PRODUCT/PROCESS CHANGE NOTIFICATION

PCN MMS-MIC/14/8685
Dated 03 Oct 2014

Conversion to High Density Matrix Leadframe - LQFP 64
10x10 products listed below

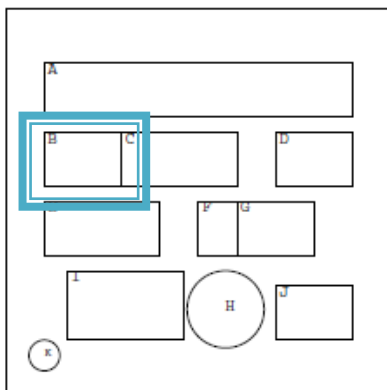
1/ For products listed below changing from STATS ChipPAC Shanghai (China) to Muar (Malaysia) assembly site:

The marking instruction indicated on the products is changing from:

B : Assembly plant changes from GH to 99

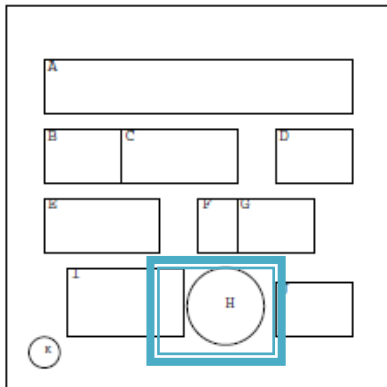
2/ For products listed below remaining at Muar (Malaysia) assembly site:

The marking instruction indicated on the products is changing from:

H : Second level interconnect changes from e4 to e3
